Inspection Report

This report concerns the Dry Film Thickness readings taken on the Zinga coatings that were applied onto the steel beams during the works being carried out below the pavement at 120 Oxford Street, Central London. The readings were taken by the contractor.

Inspection report 21-059

CONTRACTORS PHOTOGRAPHS

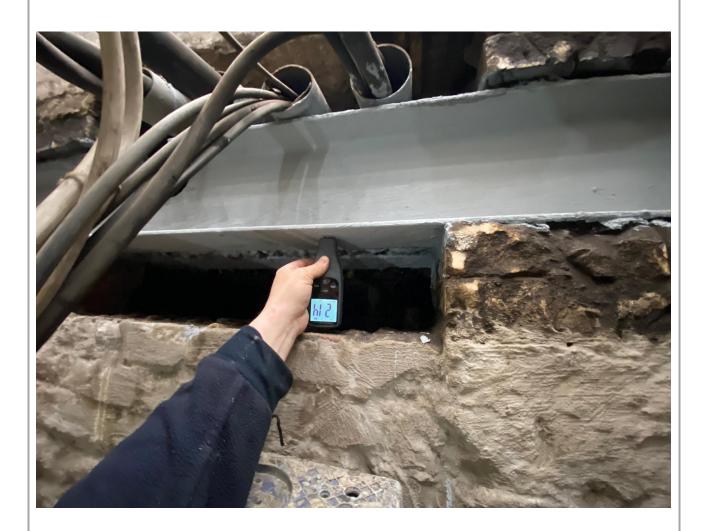
1. This reading shows 333 μ m DFT, and this is excessive. Where 180 μ m DFT has been specified, we work to SSPC-PA2 like thousands of other people in the industry, and the upper threshold limit that we work to is always 120% of the specified figure. In this case it is 180 x 120% = 216 (220 rounded-up). This beam looks like a new installation, so without seeing the 'before' photos it looks very high.

2. This fgure of $287\mu m$ DFT could be a very high reading, or there could be surface undulations or 'scalloping' over a small area. This is the reason that coating inspectors take spot-readings ie three readings taken within the size of a hand. If two are showing, for example, 220 and one is showing 300 μm DFT then the chances are that it is an errneous reading.

3. This reading is showing a value of $306\mu m$ DFT and the beam looks like a new one, so without any 'before' photographs we have to assume that the reading is very high. If it is a new beam with hih readings, then the coating must be checked carefully for micro-cracking on inside corners where the film-build tends to be higher.

4. This reading is lower than the others but still very high.

5. This reading is within the specified range.

6. This reading is well within range.

7. This reading is right on the threshold and so totally acceptable.

8. This reading was taken over an old beam, so surface corrosion defects could account for this high reading.
